**STAFF REPORT:** 11/10/2021 MEEETING

**ADDRESS:** 8016 KERCHEVAL

**APPLICATION NO:** #21-7581

**SCOPE:** ERECT DECK BETWEEN EXISTING FRONT PORCHES; REPLACE WINDOW WITH DOOR; INSTALL ADA LIFT AT REAR PORCH; AND ERECT DUMPSTER ENCLOSURE IN PARKING LOT

**A-9**

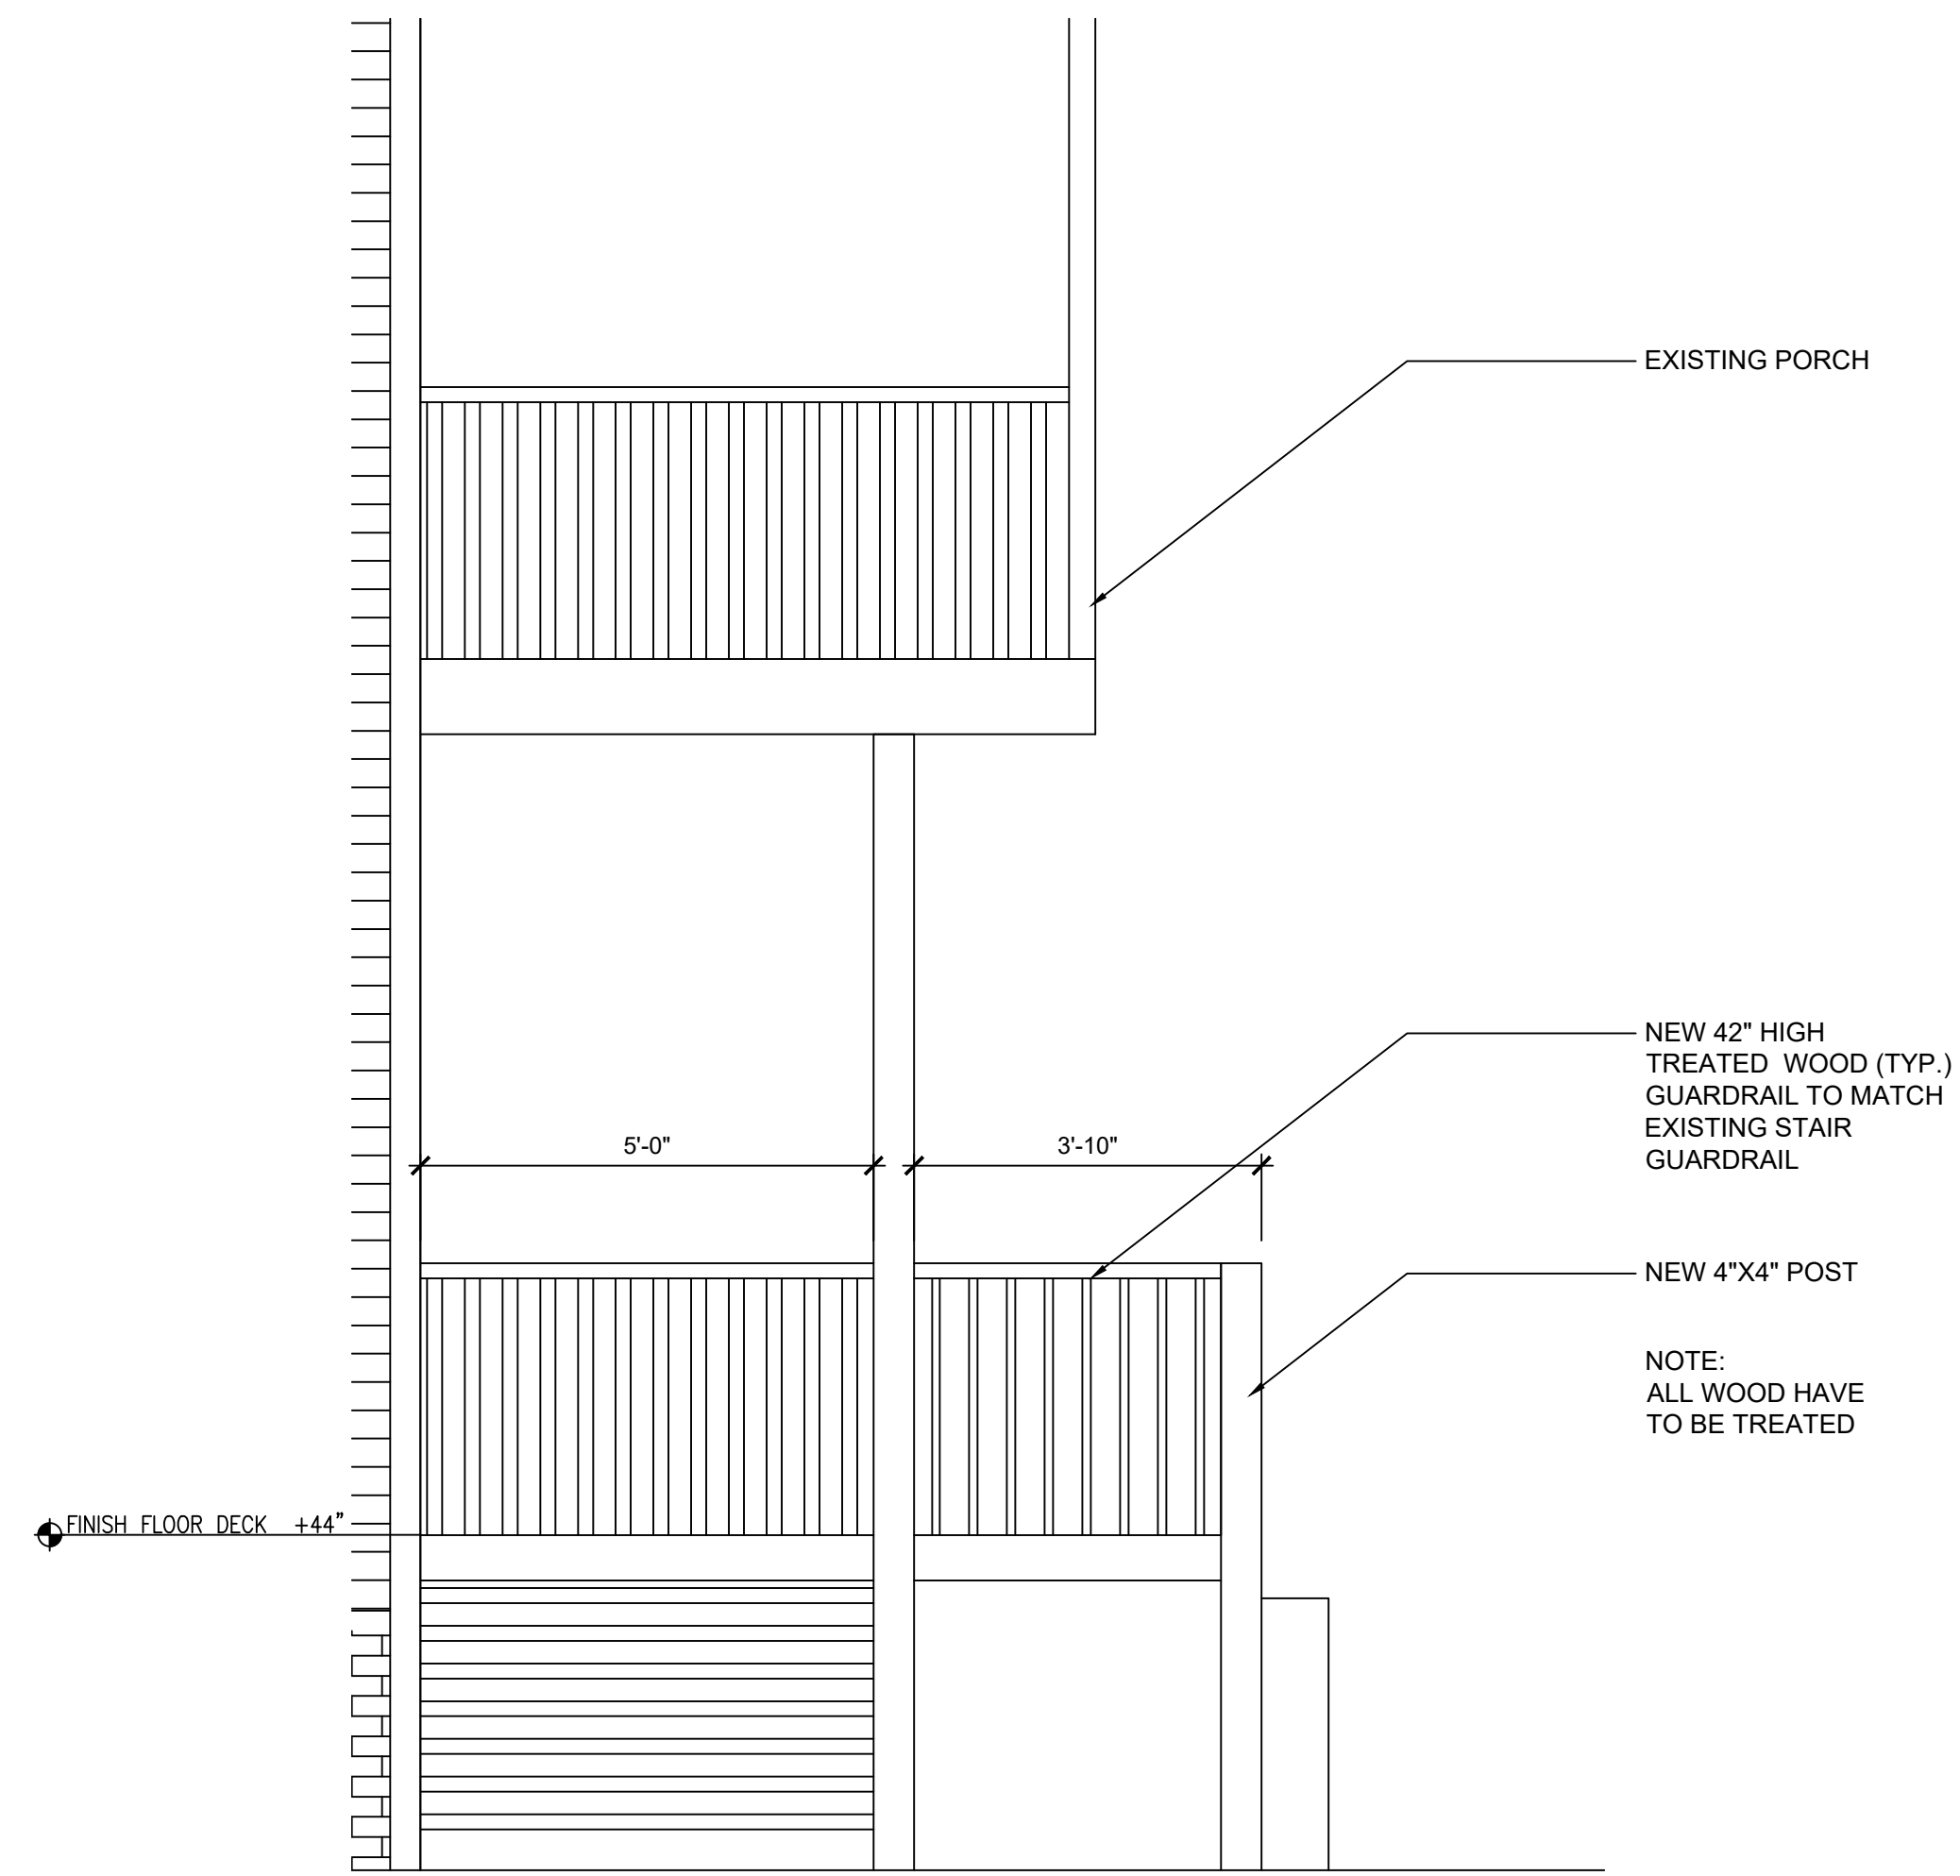
- It is staff's opinion that the front elevation window proposed for removal and replacement with a door and trim is a character-defining feature of the property. See the submitted proposed first-story floor plan. The new deck/outdoor patio space, if approved, will be accessible via the eastern door.

- As noted, the front elevation window proposed for removal and replacement with a door and trim is a highly-visible, significant character-defining feature of the property. Also, the addition of the door will detract from the original multi-family character of the building. It is therefore staff's opinion that this proposed scope item does not meet the Standards.
- The application does not specify the location of the proposed west elevation ductwork nor does it provide information re: the dimensions, material, etc, of the work item. A review of the floorplans indicate that the kitchen area is located towards the rear/southern 1/2 of the of the building. Staff would recommend that any exterior ductwork be painted a color which matches the **body** of the home, rather than the trim color.

- Remove the single, 1/1 “cottage-style” wood window and associated trim which is centrally located at the at projecting bay, first story. Lengthen the opening to allow for the installation of a new full glass, wood door with wood frame, painted to match existing black color. New door trim to match existing trim. The new door and trim will be painted black to match the existing trim. New lapped wood siding which matches the existing siding will be installed around the new door where needed to infill an gaps/openings. This siding will be painted grey to match the existing siding.

Staff recommends that the Commission **DENY** the issuance of a Certificate of Appropriateness for the following work items because they do not conform to the West Village Historic District’s Elements of Design and do not meet the Secretary of the Interior Standards for Rehabilitation, in particular, Standards #1) *A property shall be used for its historic purpose or be placed in a new use that requires minimal change to the defining characteristics of the building and its site and environment;* #2) *The historic character of a property shall be retained and preserved. The removal of historic materials or alteration of features and spaces that characterize a property shall be avoided;* #5) *Distinctive features, finishes, and construction techniques or examples of craftsmanship that characterize a property shall be preserved;* and #9) *New additions, exterior alterations, or related new construction shall not destroy historic materials that characterize the property. The new work shall be differentiated from the old and shall be compatible with the massing, size, scale, and architectural features to protect the historic integrity of the property and its environment:*

- The decking and steps at the two existing front porches shall be painted or stained a color which complements the building’s trim color. The new deck shall be painted or stained a color that corresponds with the color which will be applied to the deck and steps at the two existing front porches. The color of the railing at the new front deck shall match the railing

at the two existing front porches. The applicant shall provide a color palette for the decks to HDC staff for review and approval prior to the issuance of the project permit.
